# LL Patch Update

## What You Can Expect

### File Size Comparison with the LL Patch

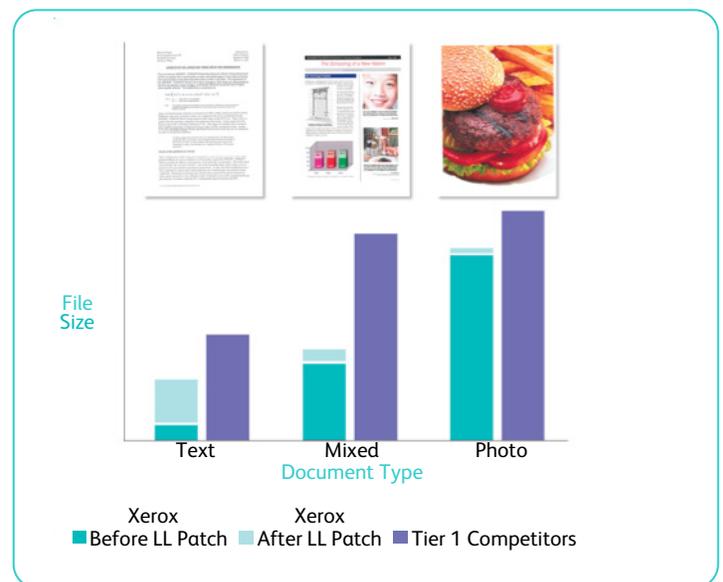
There are no noticeable differences in the operation of your Xerox® MFP after the LL patch is installed. Xerox® MFPs will continue to use industry standard compression, but without the more aggressive file compression that may result in character substitution. Therefore, extremely small file sizes for text will no longer be offered. There will be minimal impact to file sizes for mixed and photo documents. All of these documents will continue to have very good compression with file sizes that are competitive in the industry based on Xerox testing (see chart on right).
